## Duquesne Light

SUBJECT: Beaver Valley Power Station - Unit No. 2  
Docket No. 50-412  
Mechanical Engineering Branch Questions Dated November 26, 1985

MECHANICAL ENGINEERING BRANCH  
REQUEST FOR ADDITIONAL INFORMATION

### Response to MEB Questions

CLIENT DUNSMUIR LIGHT CO LOCATION B.V.2  
 SYSTEM SERVICE WATER PIPING (AUX. BLDG. & BURIED) SHEET 1 OF 4  
 CALCULATION NO. 12241-NP(T) X 257-X9 REV: 0

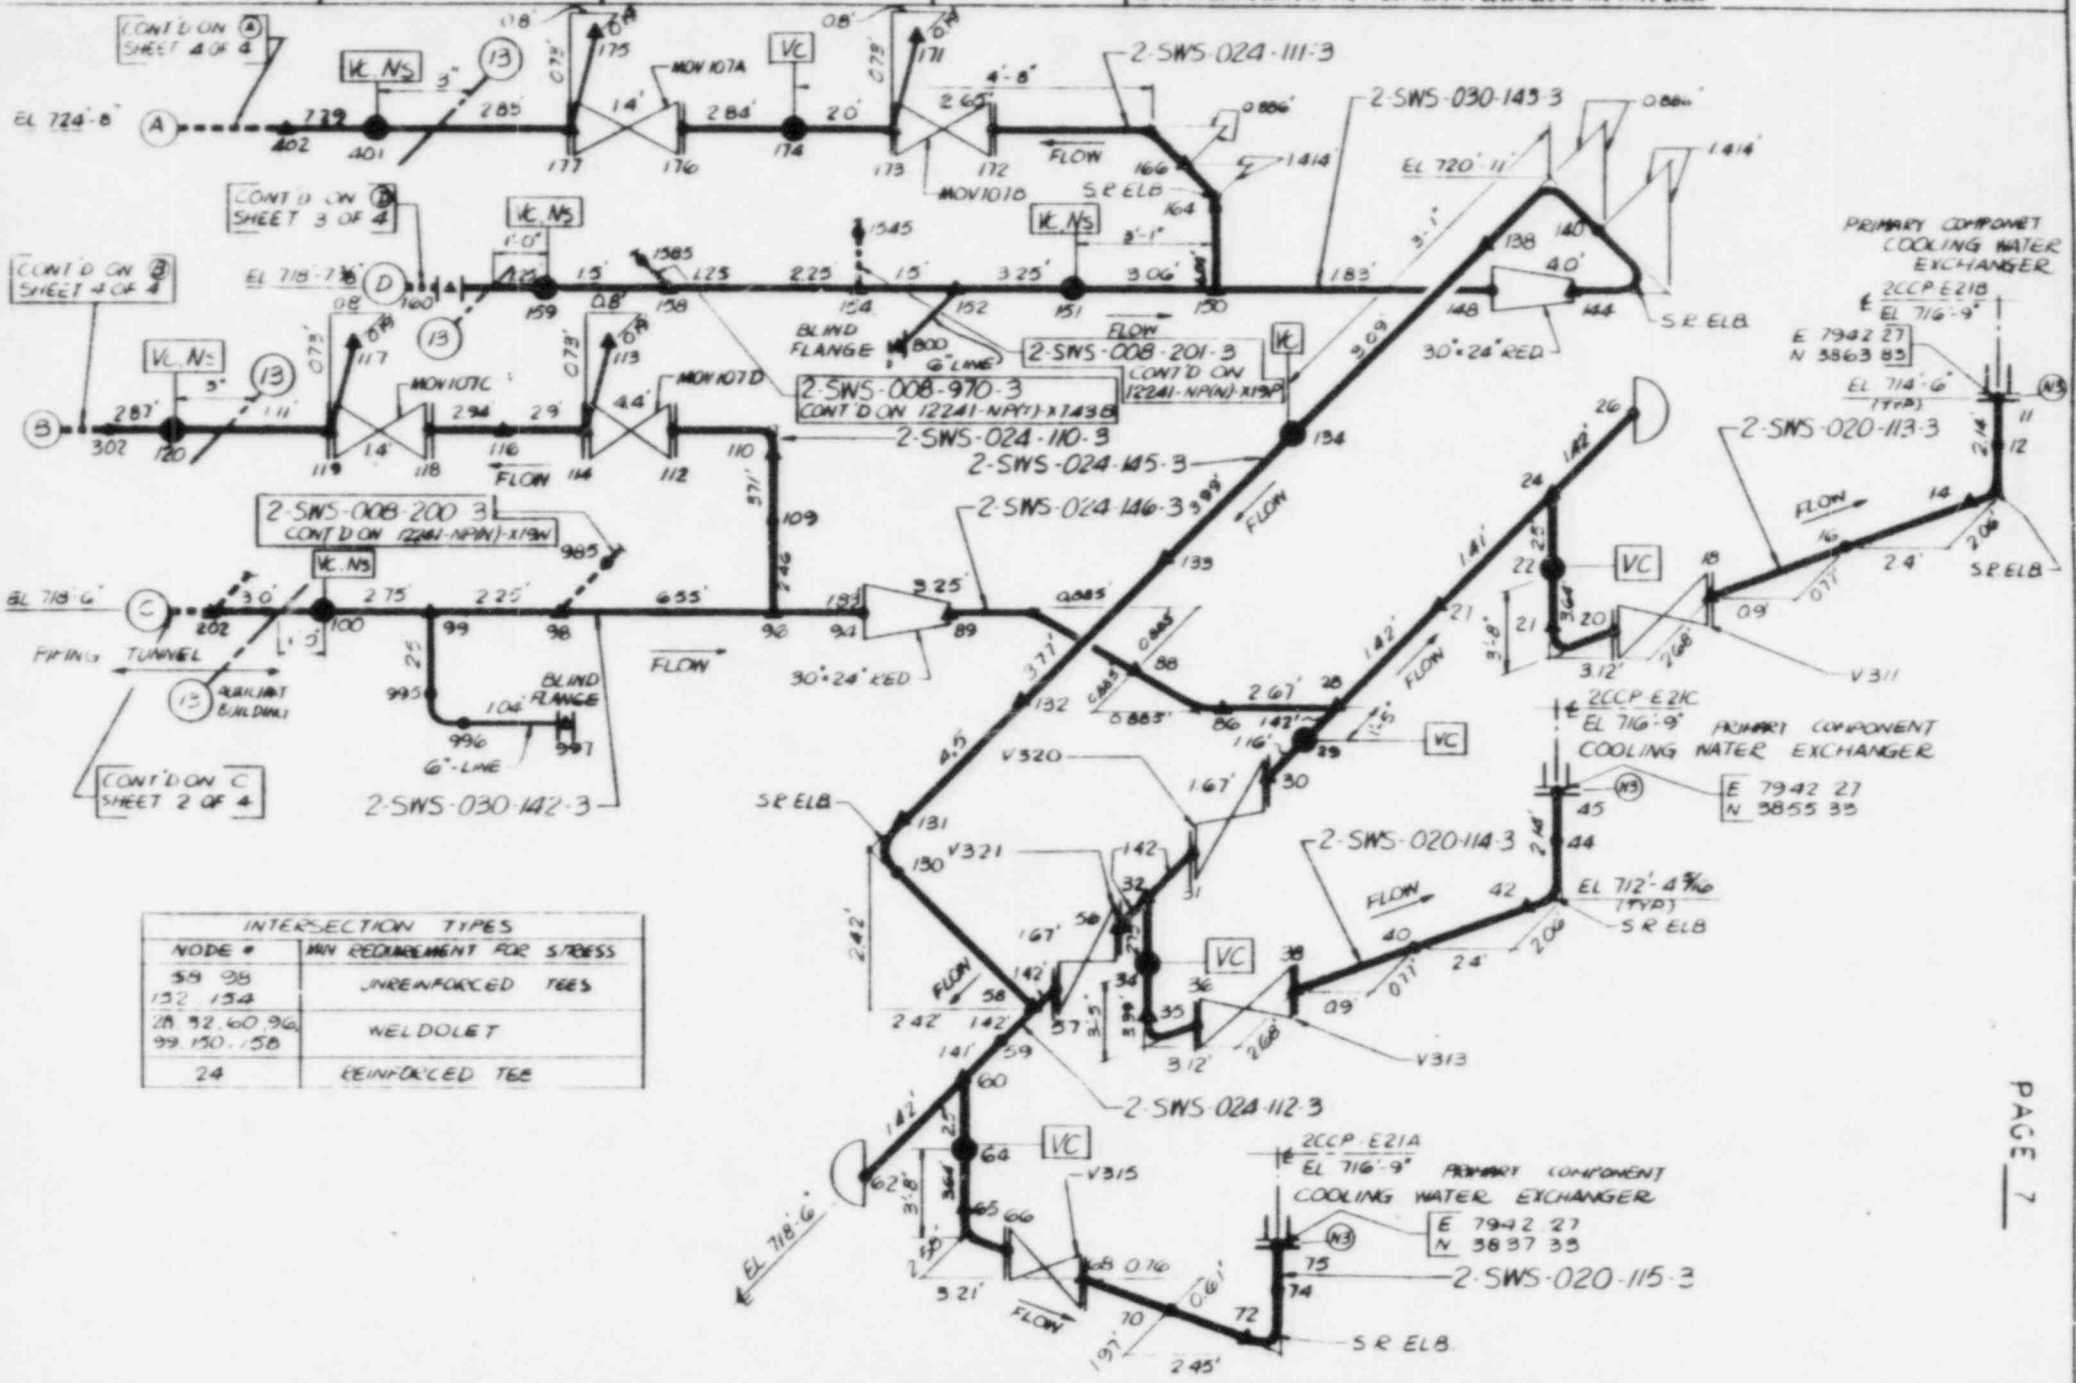
- (11) The Seismic Analysis does not cover the analysis of the bolted-flanged joint connecting the valve to the piping. This is acceptable provided the adequacy of the joint is checked as some part of the evaluation. To complete our audit on this aspect, please provide the documentation (perhaps a Pipe Stress Calculation package) which includes evaluation of the flanged joint for the valve covered by the Seismic Analysis.

10. Manufacturer valve drawing SWEC File No. 2006.450-76A-072K, Attachment "D."
11. SWEC evaluates moment loadings on all flanged joints in ASME III piping as part of pipe stress analysis. These particular flanges are evaluated in pipe stress calc 12241-NP(T)-257-X9, Attachment "E."

Figure VII-1100(2.1) Chart for Determining Shell Thickness of Cylindrical and Spherical Vessels Under External Pressure.

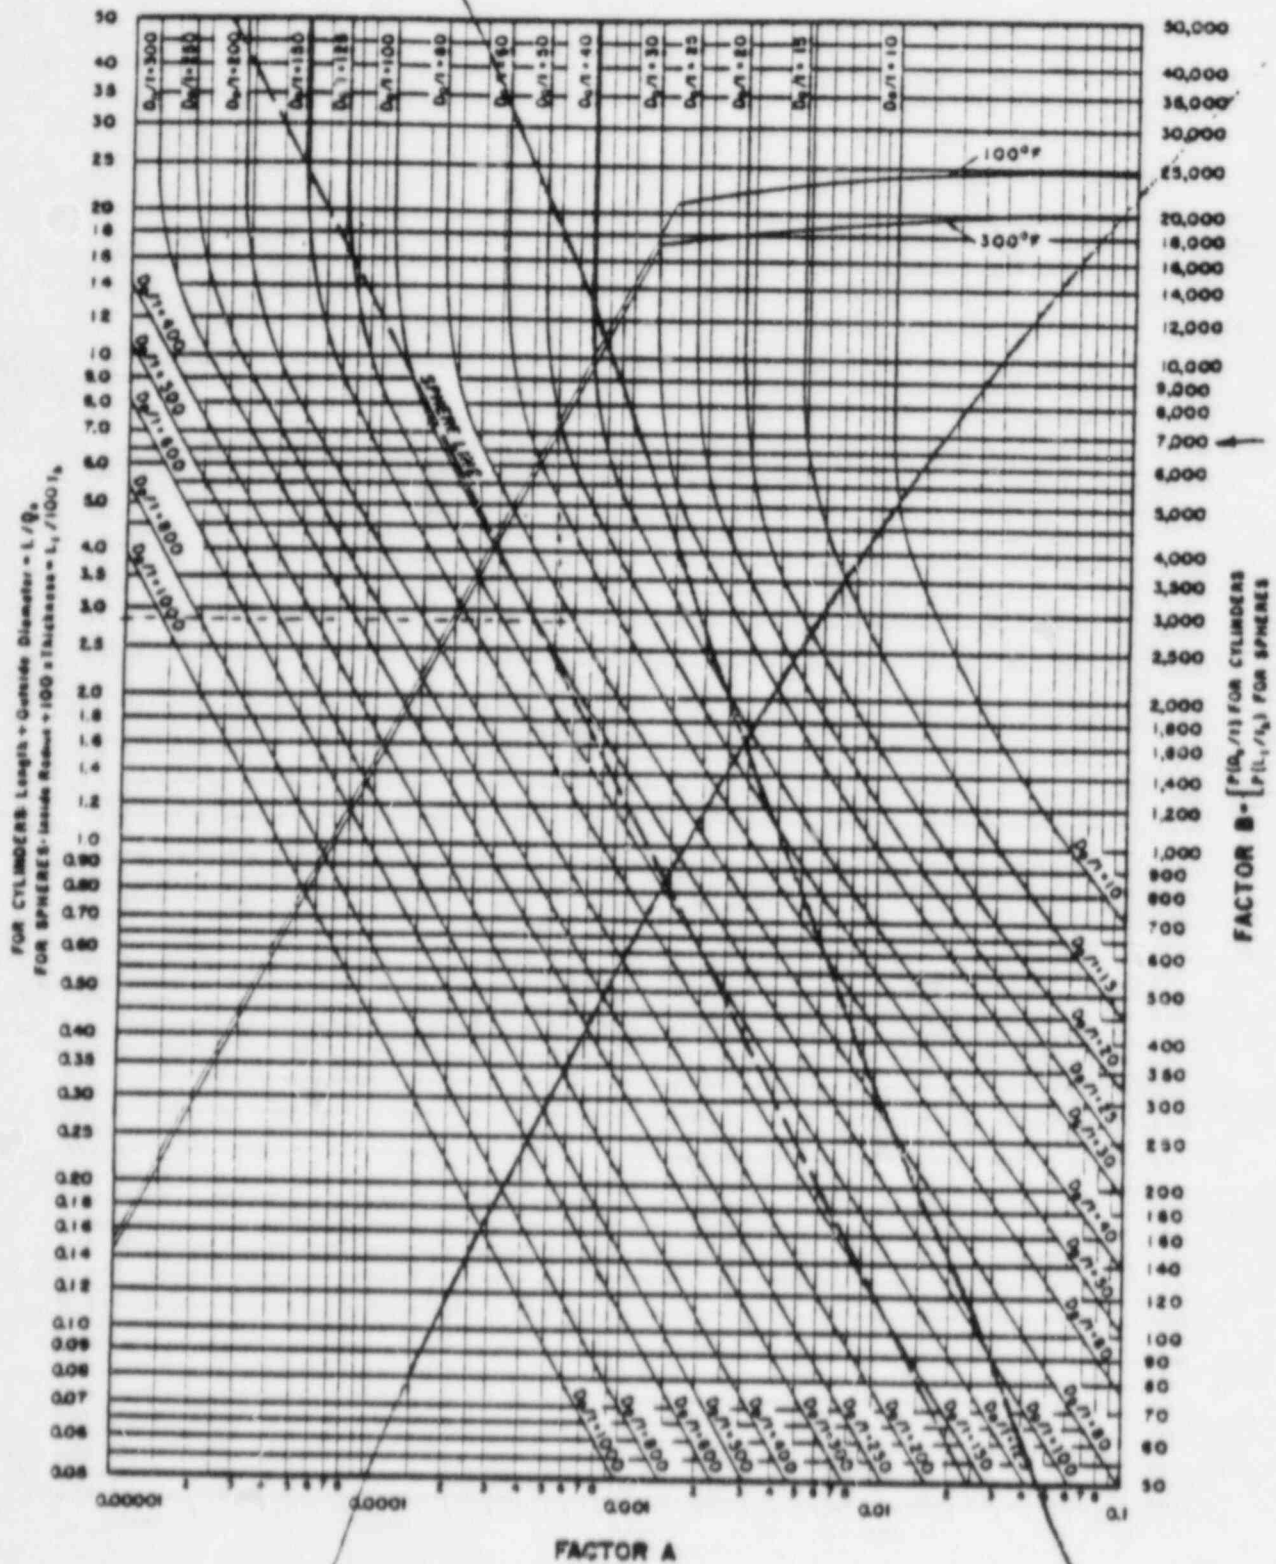
(c) NC-3641.2 is on straight pipe under external pressure. How is this Code requirement checked? For example, 2BVS-76A, p. 1-26, indicates a possibility of a 45 psi pressure existing inside containment, which implies a possibility of a 45 psi external pressure on piping inside containment. 2BVS-939A, for Class 151, includes pipe up to 42-inch size with 3/8-inch wall. The Code allowable external pressure for that pipe is about 15 psi. We do not find any restriction or warning that this pipe may not be suitable for use inside containment.

- 15c. As indicated in our response to Question 15(b), the 42 in. purge line through the containment wall is the only 42 in. piping at BVPS-2. Applying Paragraph NC-3461.2 to this piping, it was determined that this piping can withstand 109 psi of external pressure, see Attachment "G" for calculation.
